DF9 Series - Embossed Carrier Tape Shape Change

DF9 Series - Embossed Carrier Tape Shape Change (Addition of Overlap-Prevention Shape)

DF9 Series - Embossed Carrier Tape Shape Change (Tape Width Change)

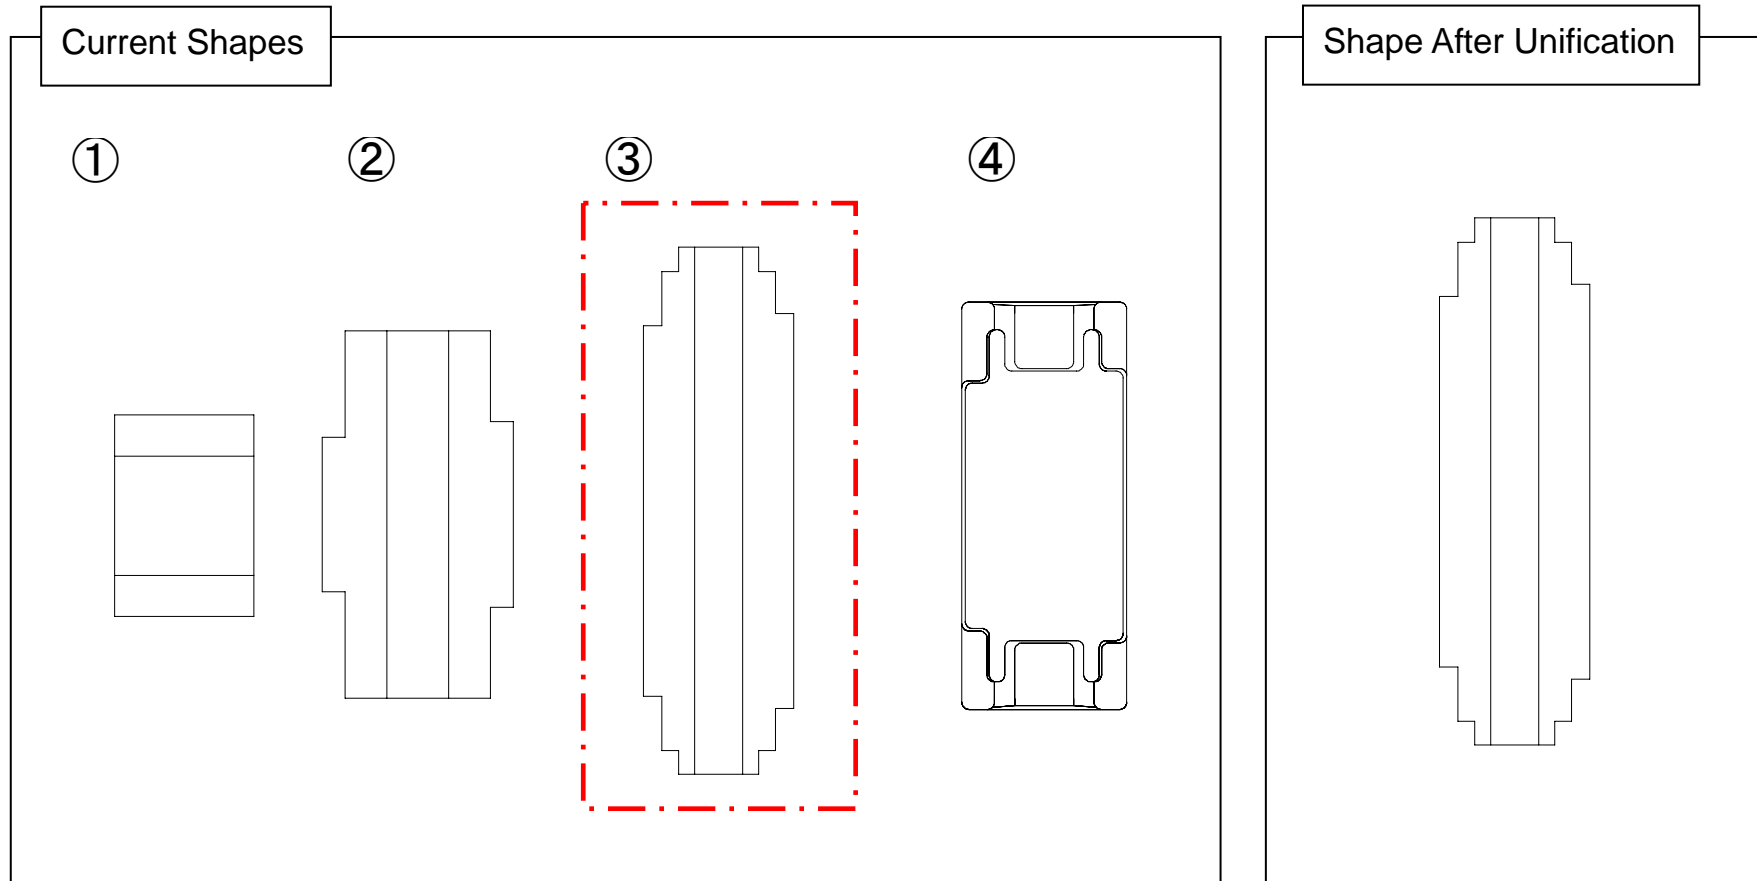
The shape is being unified to current shape (3). If you use shape (3), there is no change.

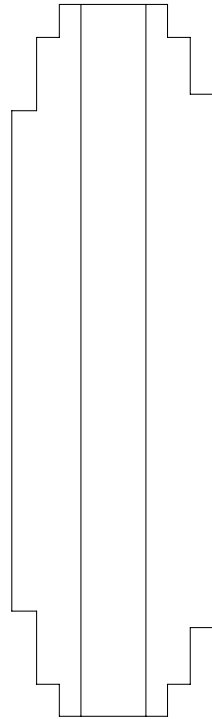
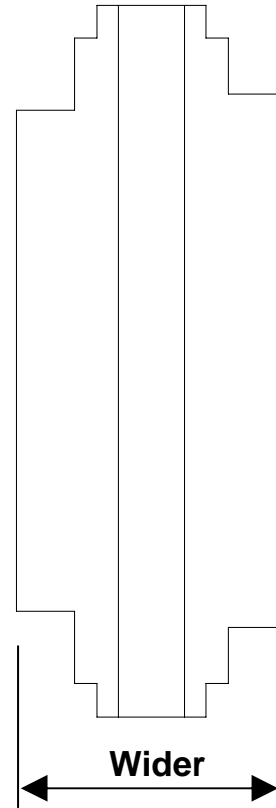
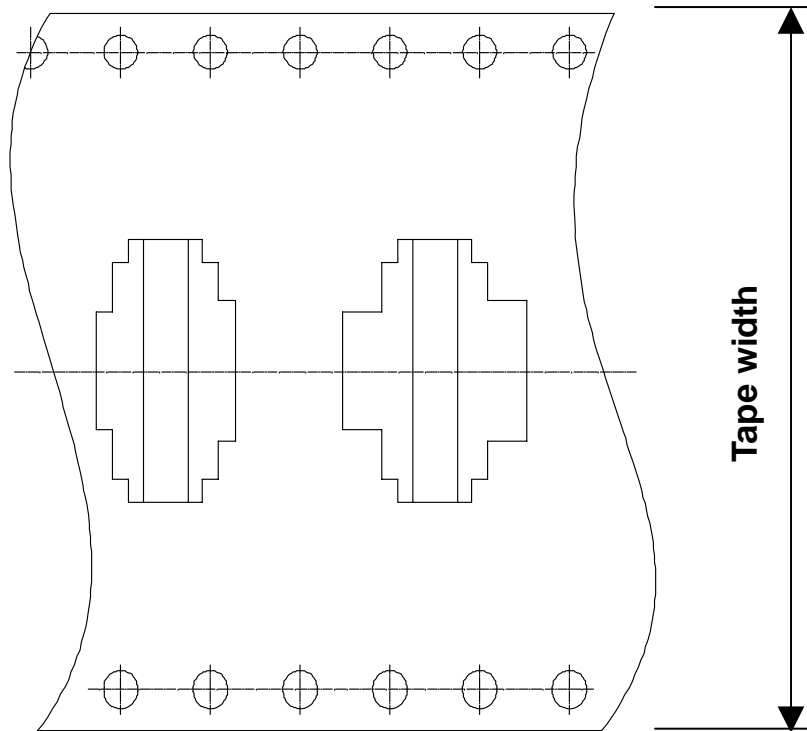
- One of the cavities serves as an overlap-prevention pocket.
- There are no changes in the connection packaging position.

DF9 Series - Embossed Carrier Tape (Pitch Change)

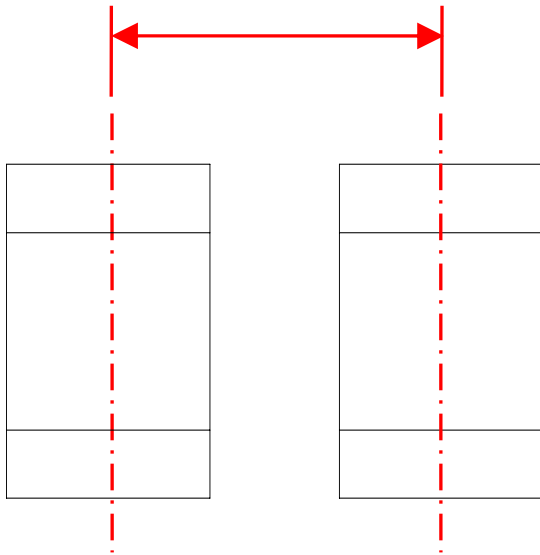
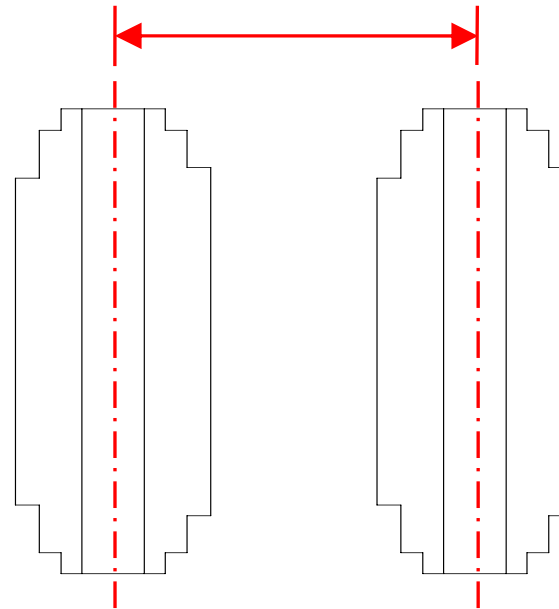
If you use current embossed carrier tape shape (1), the pitch will change.

Pitch Before Change: 8 mm

Pitch After Change: 12 mm

DF17 Series - Embossed Carrier Tape Shape Change (Addition of Overlap-Prevention Shape)

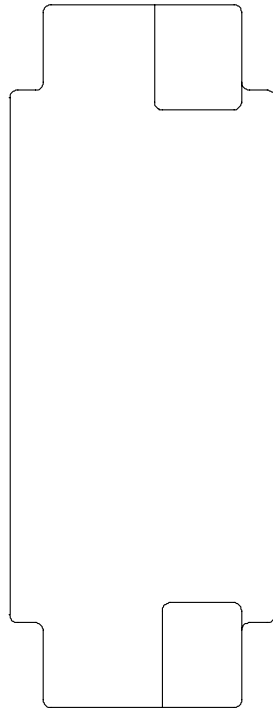
- One of the cavities serves as an overlap-prevention pocket.
- There are no changes in the connection packaging position.
